FACILITY: Trojan Nuclear Plant

SUMMARY OF MEETING HELD ON OCTOBER 18 AND 19, 1979 WITH PORTLAND GENERAL ELECTRIC COMPANY AND BECHTEL TO DISCUSS THE TROJAN CONTROL BUILDING MODIFICATIONS

At this meeting, PGE submitted preliminary written responses to 19 of the 48 questions and requests for information propounded by the NRC staff in letters dated September 14, 20, 28 and October 2, 1979. These draft responses are shown in Attachment 2.

The attached Fig. 2-1 shows the projected area used for computing the equivalent diameter of the plate washer impact.

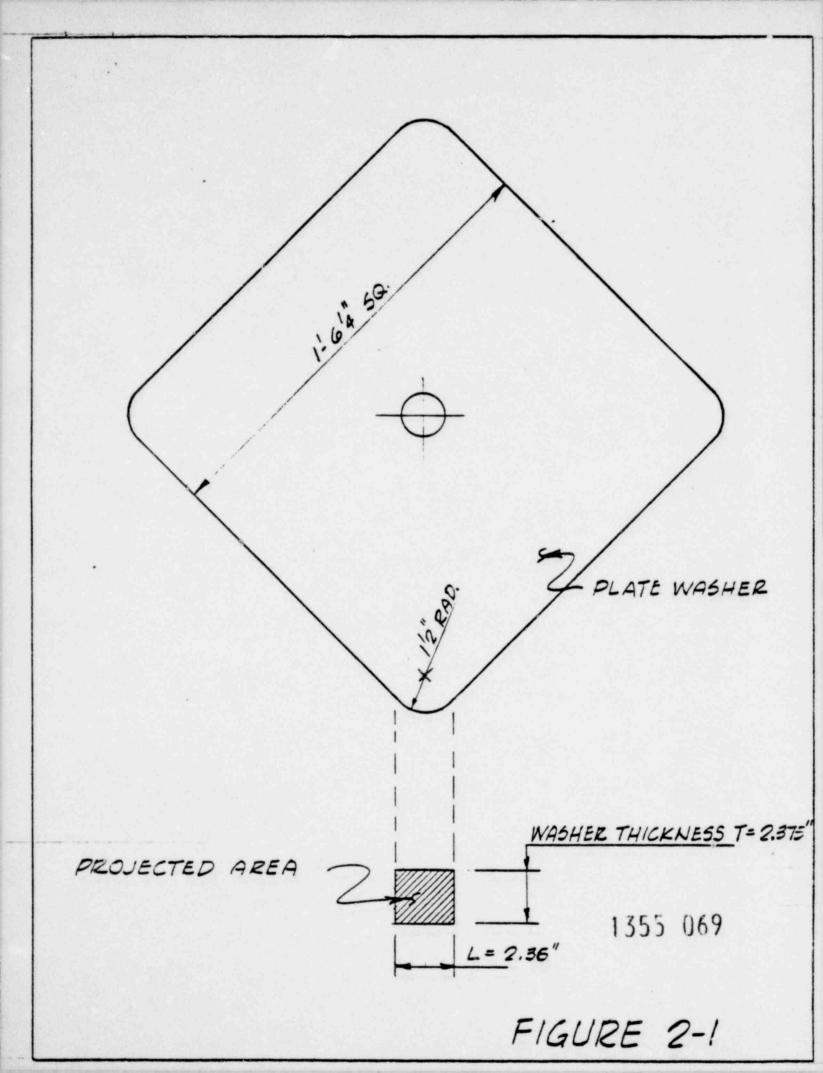
- Provide a detailed description of how the equivalent diameter was determined which was used in computing the penetration of the dropped washer into the steel cover plate for cable trays.
- Provide a drawing which illustrates the projected area used for computing the equivalent diameter.

An evaluation of the postulated drop of a plate washer on the steel cover trays was provided in Licensee's response dated September 5, 1979 to Systems Branch Question 11. In the equation used, the term "D" is the diameter of the missile. For an irregularly shaped missile, such as the corner of the plate washer, an equivalent diameter must be used in the analysis.

The equivalent diameter 1: taken as the diameter of a circle with an area (A) equal to the circumscribed contact area or projected frontal area of the noncylindrical missile. (Reference: page 2-4, Bechtel Topical Report BC-TOP-9A, Rev. 2).

The contact area (A) is the plate thickness (T) times the arc length (L) of the rounded portion of the plate washer.

$$L = \frac{2\pi R}{4} = \frac{2\pi (1.5)}{4} = 2.36 \text{ in}$$

$A = TL = (2.375)(2.36) = 5.6 in.^2$

$$D = \sqrt{\frac{4A}{\pi}} \sqrt{\frac{4(5.6)}{\pi}} = 2.67 \text{ in.}$$

Figures 3-1 through 3-4 show locations of the above described wood form work. These figures are the same as attached to the answer to NRC Question No. 7, dated July 20, 1979.

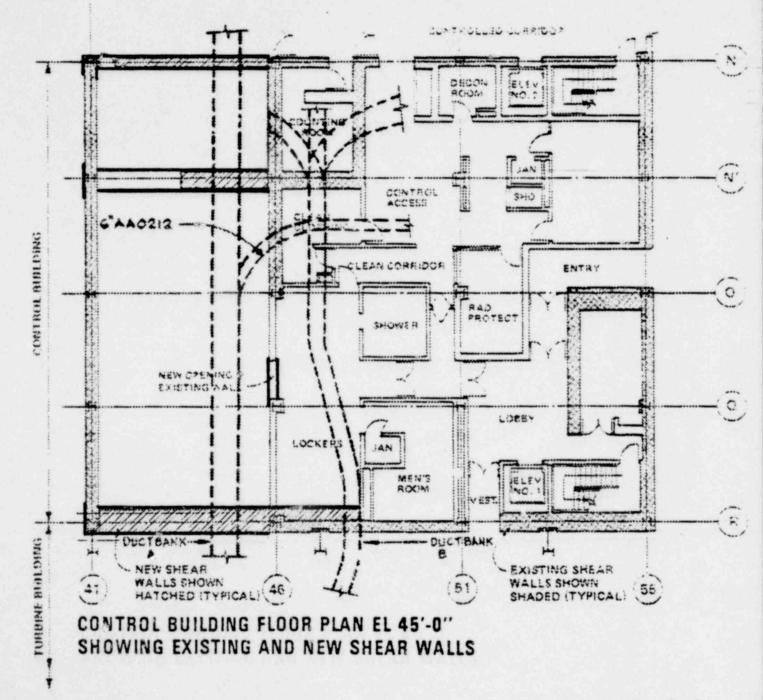
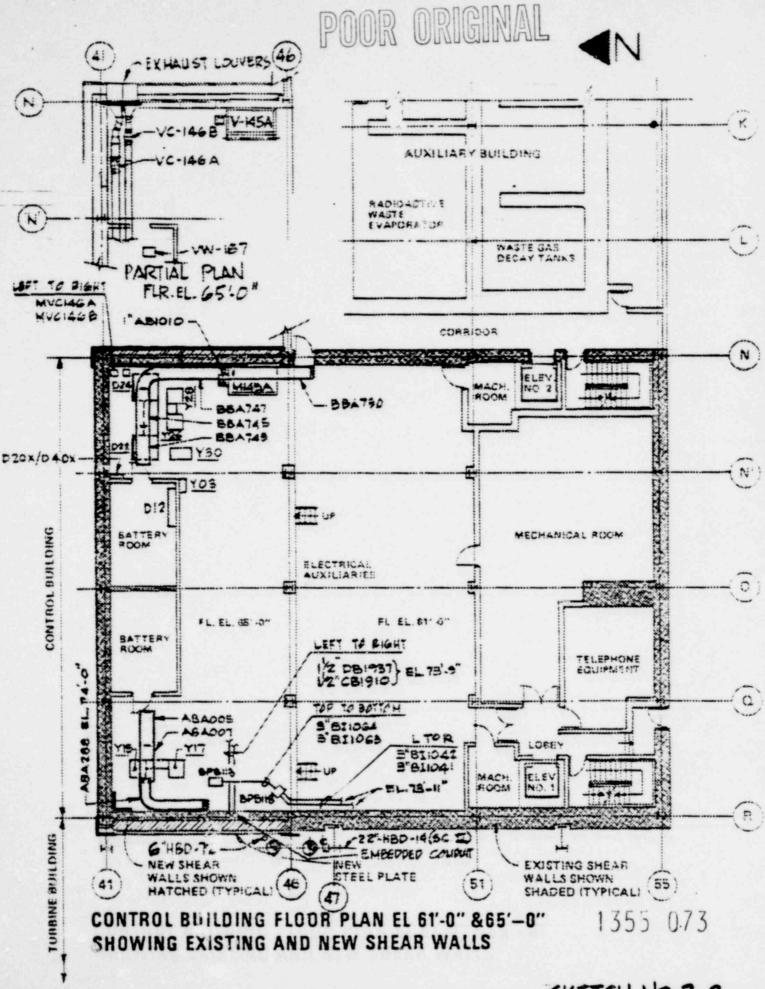
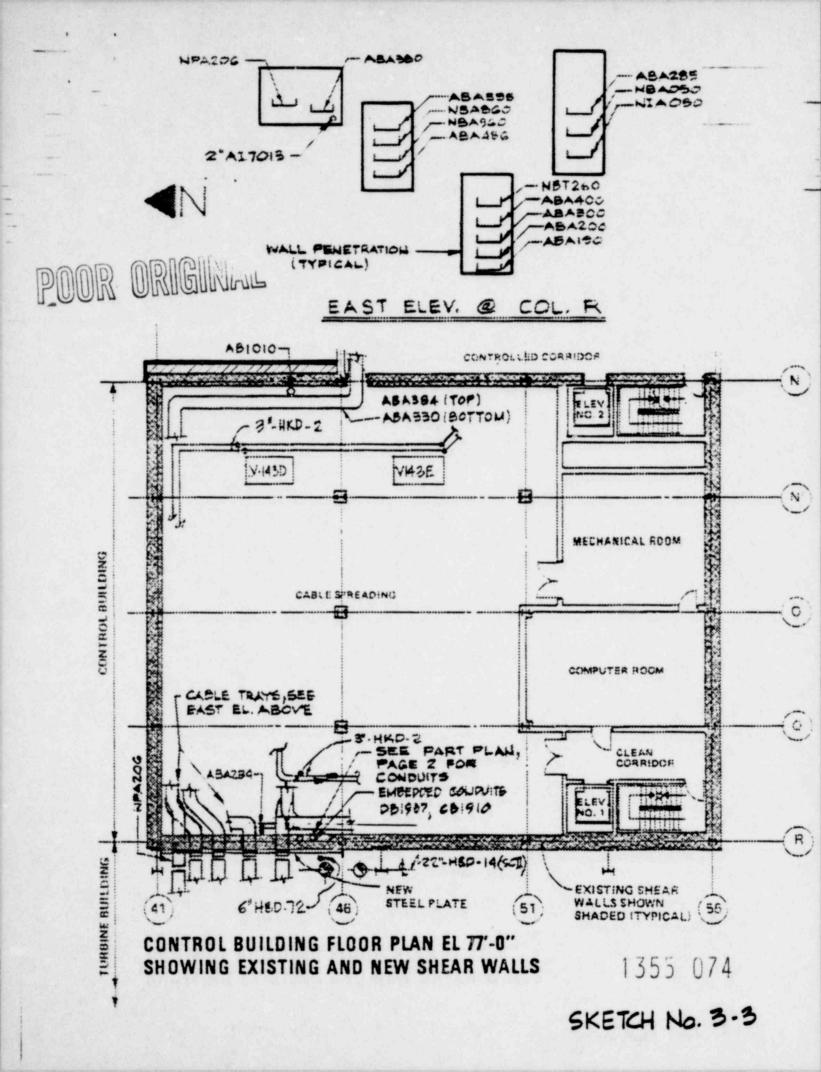
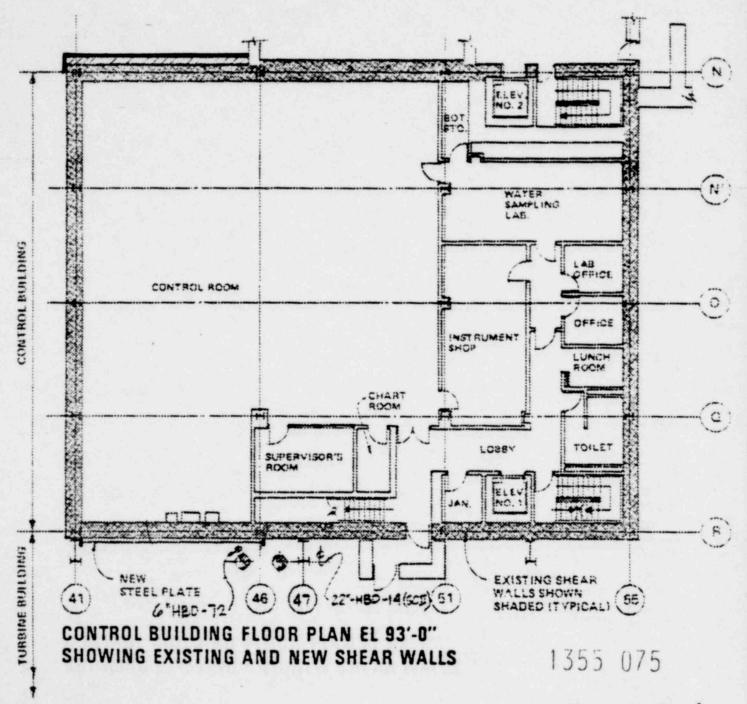
Provide a listing of all areas containing safety-related cables or equipment in which wood framing will be used during the modification work.

Wood will be used during the modification program for form material for placing concrete for the new walls along column lines N, ' and R, and along column line Q as follows:

Within the above areas the following locations where wood forming will be used contain safety related cables or equipment:

In the Electrical Auxiliaries Room along column Line N around the equipment hatch and around the columns at the intersection of column lines R and 41.

- On the east (outside) side of the N line wall, at approximate el. 72' around the battery room exhausts.
- 3) On the west side of R line wall between elevations 69' and 93' around the edges of the steel plate.
- 4) Below grade where wood form work may be required for the grade beams supporting the new R, N' and N line walls. This form work, if needed, would be located in the vicinity of the service water piping, diesel fuel oil lines and the electrical duct bank. A minimum of 3 inches of sand will separate those items from the above form work.

. PLATE #7 "SHOE" - HEXCEL PAD (TOP OF PLATE # 4) BRACKET TO SUPPORT HEKCEL PAD -21" GROUT PLATE#4 2 WEST FACE OF R WALL 1355 092 SECTION A-A FOR LOCATION SEE FIG. 6-3 FIGURE 6-4

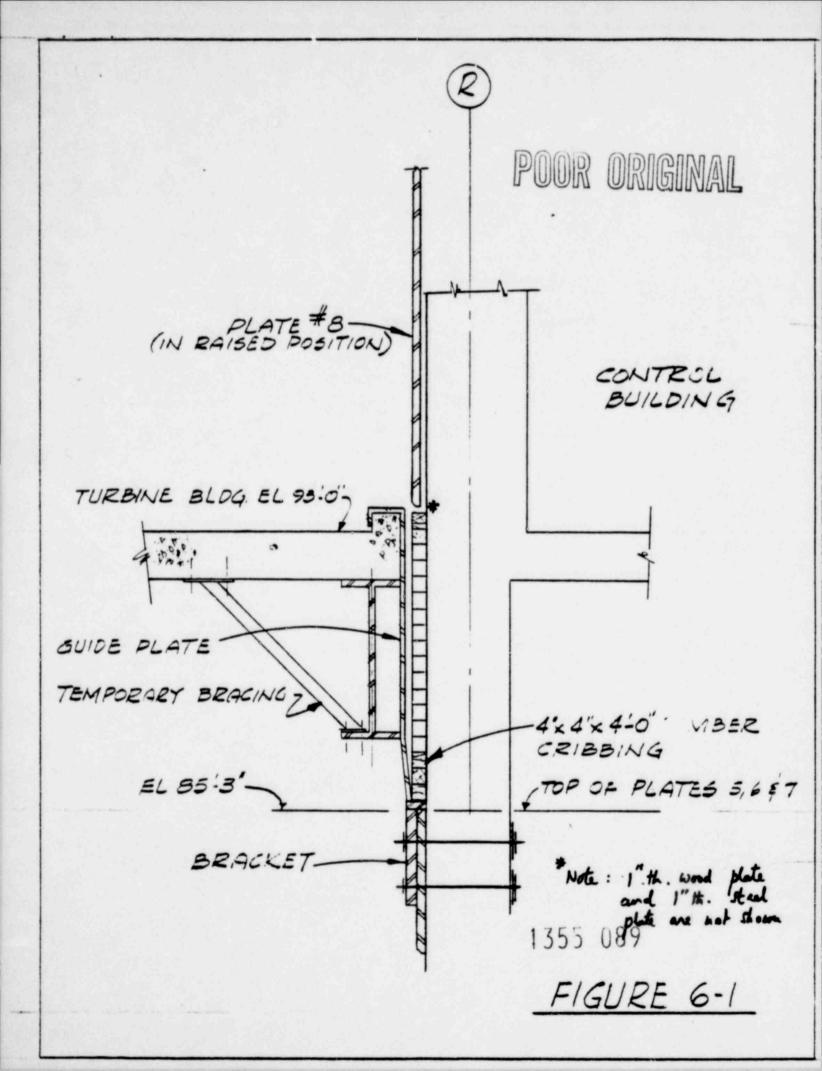
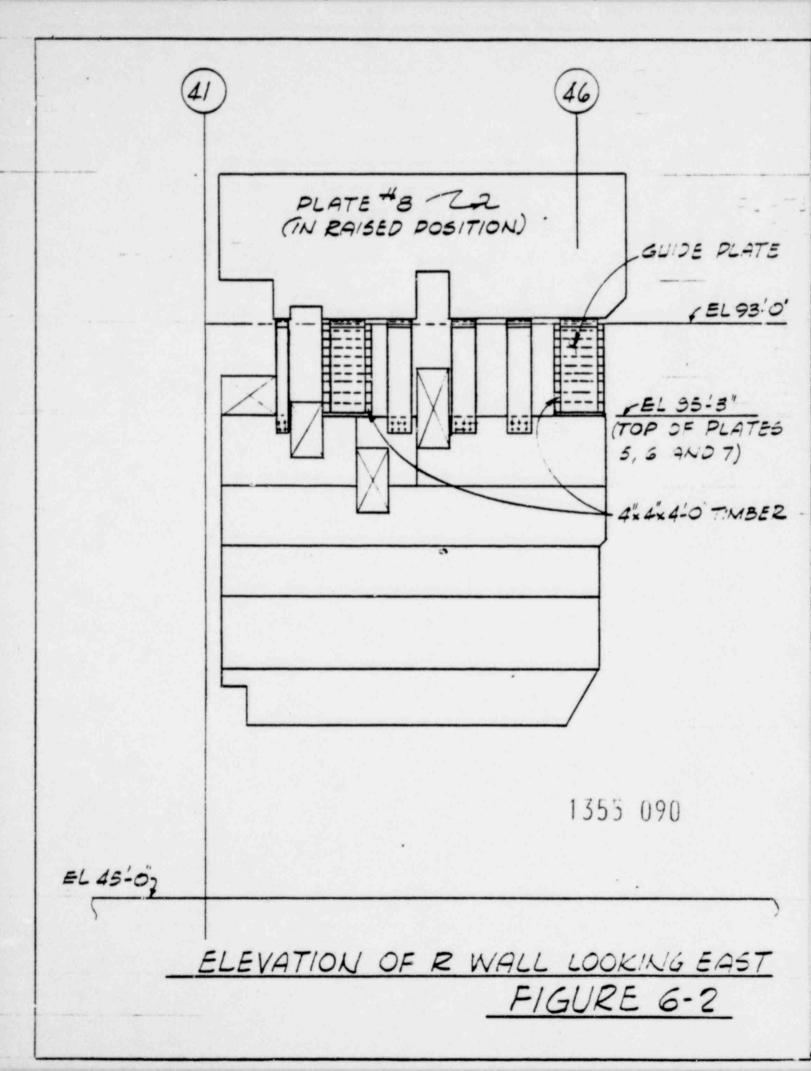
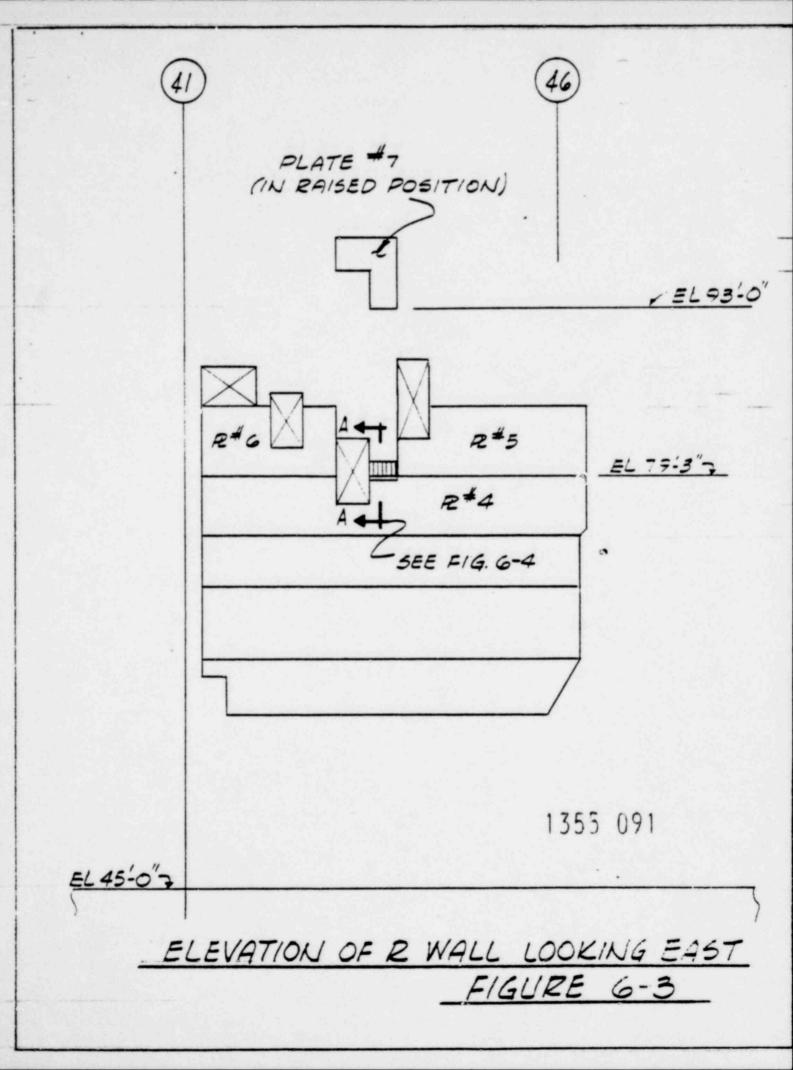
Provide the results of your analyses showing that plates 1 through 6 are sufficient to sustain without detrimental effects on plates 1-6, the structure, equipment, piping, or cable trays, the impact of plate 8 should a drop of plate 8 occur. Include (a) a detailed description of all assumptions used in the analyses, and (b) detailed justification for all of the assumptions used in the analyses, all of the loads and all of the acceptance criteria relied upon. Include an identical discussion for plate 7.

To preclude any possibility of detrimental effects on Plates 1-7, the structure, equipment, piping or cable trays should a drop of Plate 8 occur, the maximum drop height of Plate 8 will be limited to 4 inches by placing timber cribbing on top of Plates 5, 6, and 7 as shown on the attached Figures 6-1 and 6-2. The timber cribbing will consist of two piles of 4" x 4" x 4' long pieces stacked on top of each other. As the plate is being lowered, 4" thick segments will be removed one at a time from each pile, thus limiting the drop height of Plate 8 on wood to approximately 4". The last piece removed from each pile will be 1" thick, thus further reducing the drop height of Plate 8 on the plates below to 1".

The timber cribbing will be made using Douglas Fir or similar wood. It will be supported on the bottom by brackets attached to the lower plates. The cribbing will be braced laterally by guide plates designed to prevent bulging and subsequent

Steps will be also taken to preclude any possibility of detrimental effects on Plates 1-4, the structure, equipment, piping or cable trays should a drop of Plate 7 occur. A corrugated aluminum HEXCEL pad, stabilized and precrushed, will be placed on Plate 4 to absorb the energy of the drop. The HEXCEL pad will be 4" wide, 24" long, and 17" thick. It will be attached to the top of Plate 4 as shown in Figures 6-3 and 6-4. A "shoe" under Plate 7 will spread the load. The Z bars shown in Figure 4-1 in Licensee's response dated September 5, 1979 to Systems Branch Question No. 9 will guide the plate.

Weight of Plate 7,	W	=	3 kips
Maximum drop height,	Н	=	14.75 ft.
Maximum kinetic energy,	KE	=	3 x 14.75 = 44.25 ft-kips
0	- KE	=	44.25 x 1000 x 12 = 531,000 in-1bs

Figure 2-1

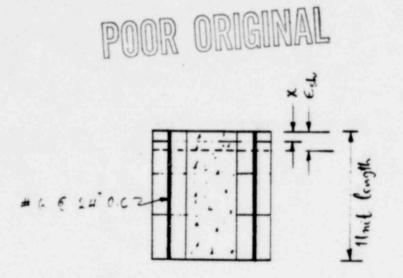
In your July 10, 1979 response to question 13, an unrestrained strain of 100 x 10 exp -6 in/in (and a restrained strain of 70 x 10 exp -6 in/in) is assumed for the in-situ walls. In your September 5, 1979 response to question 11, an unrestrained shrinkage strain of 280 x 10 exp -6 in/in is assumed for the new walls. In your September 5, 1979 response to question 22, shrinkage strains are calculated to be 174 x 10 exp -6 in/in for the new walls and assumed to be 200 x 10 exp -6 in/in for the existing walls, the latter being based upon the assumption that new concrete placed against the existing wall causes the existing to swell (as would be the case for the block when the core concrete was placed). These values are extremely inconsistent. Justify this inconsistency in detail, and provide calculations indicating how each was established (in addition to those already provided) along with justifications for all assumptions (including those for calculations already provided), including details of the associated concrete mixes.

The grouted masonry block walls, along with their continuous reinforcing steel, will inhibit the unrestrained free shrinkage of the core concrete. The following analysis of the existing Complex walls illustrates the restraining effect and also determines the value of restrained shrinkage in the wall. In determining the restraining effect, the wall at el. 45' is assumed to be vertically held and the entire height of the wall is considered to tend to shrink down. A 12-inch length of wall is taken for analysis. Thickness of the wall is 30 inches. See figure 2-1 for the analytic model.

FIGURE 8-1

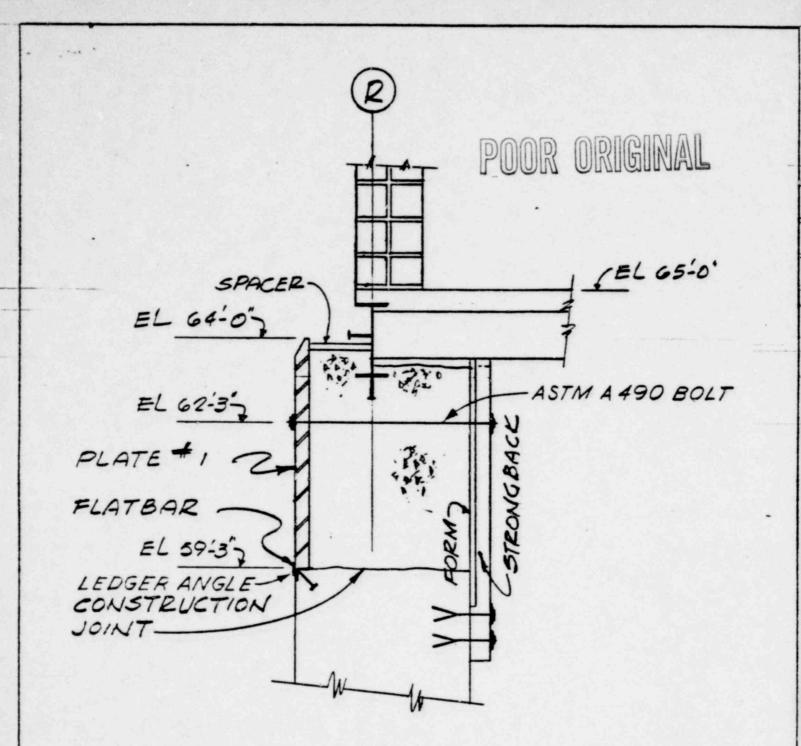
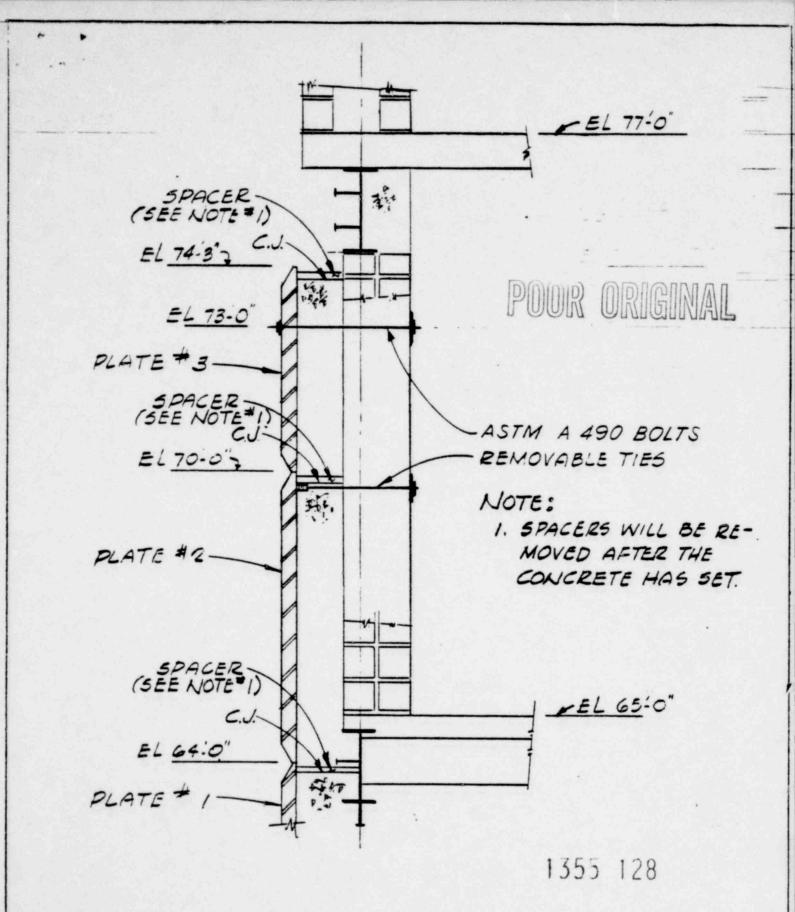
In your September 5 responses to questions, the response to question 17 indicates that for the combination of dead, live and SSE loadings, the maximum allowable stress in bending and tension is limited to 0.9 fy and the maximum allowable shear stress is limited to 0.5 fy. Verify that this limitation was imposed for the evaluations of steel elements discussed in the responses to questions 18 and 25.

In Licensee's responses dated September 5, 1979 to Structural Branch Questions Nos. 18 and 25, the maximum allowable stress in bending and tension of the steel elements was limited to 0.9  $f_y$  and the maximum allowable shear stress was limited to 0.5  $f_y$  for the load combinations referred to.
